UNITED STATES PATENT AND TRADEMARK OFFICE

APPLICATION NO.	FILING DATE	FIRST NAMED INVENTOR	ATTORNEY DOCKET NO.	CONFIRMATION NO.
10/037,525	10/24/2001	Joseph Georgiano		7306

Office Action Summary

DETAILED ACTION

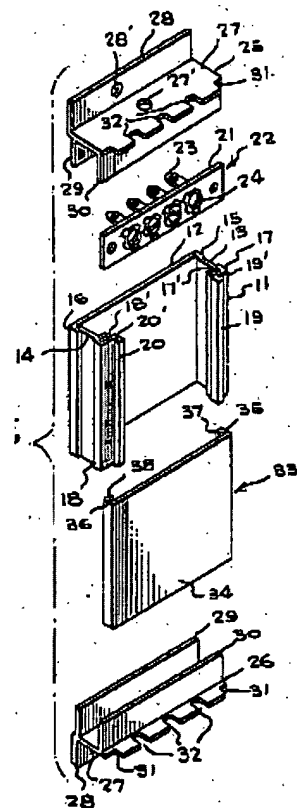
21. Regarding claim 4, a first flange 19 extends outwardly from the top surface of the top member 13 of said first member 11.

22. Regarding claim 5, a second flange 20 extends outwardly from the bottom surface of the bottom member 14 of said first member 11.

23. Regarding claim 6, said first flange 19 is generally perpendicular to the top surface of the top member 13 and generally parallel to the base.

24. Regarding claim 7, said second flange 20 is generally perpendicular to the bottom surface of the bottom member 14 and generally parallel to the base.

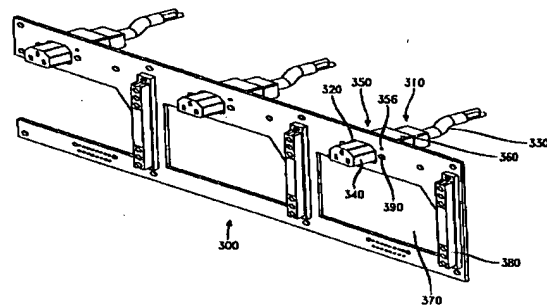
45. Regarding claim 23, Mattingly discloses a system comprising one module according to claim 1 as noted above, but does not expressly disclose a face plate for linking the modules together. However, Mattingly does disclose the module to be mounted on an appropriate supporting surface. Therefore, it would have been obvious to provide the supporting surface (i.e. face plate) in order to provide stability to the device. The functional limitation “for linking the modules together” has not been given patentable weight because it is in narrative form.

47. Regarding claims 24-27, Mattingly does not expressly disclose said face plate to be generally rectangular in shape with a top edge, a bottom edge and a pair of side edges; wherein the face plate is provided with one or more openings that correspond to openings in the modules; wherein the openings are preferably rectangular in shape, having two long sides and two short sides; wherein there are first and second orifices on said face plate that correspond to orifices in said module for receiving a connecting means for connecting the module to the face plate.

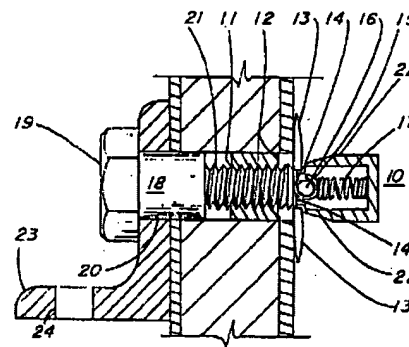
48. Nguyen et al. discloses a face plate 300 for linking a plurality of modules together, the face plate is provided with one or more openings 320 that correspond to openings in a module 310, wherein the openings are substantially rectangular in shape, having two long sides and two short sides, and wherein there are first and second orifices 390 on said face plate that correspond to orifices on the module 310 for receiving connecting means for connecting the module to the face plate 300.

50. It would have been obvious to one having ordinary skill in the art at the time the invention was made to provide the face plate such as that disclosed by Nguyen et al. for linking a plurality of modules of Mattingly together.

51. One of ordinary skill in the art would have been motivated to provide the face plate in order to provide a self-aligned module system providing ease of assembly.
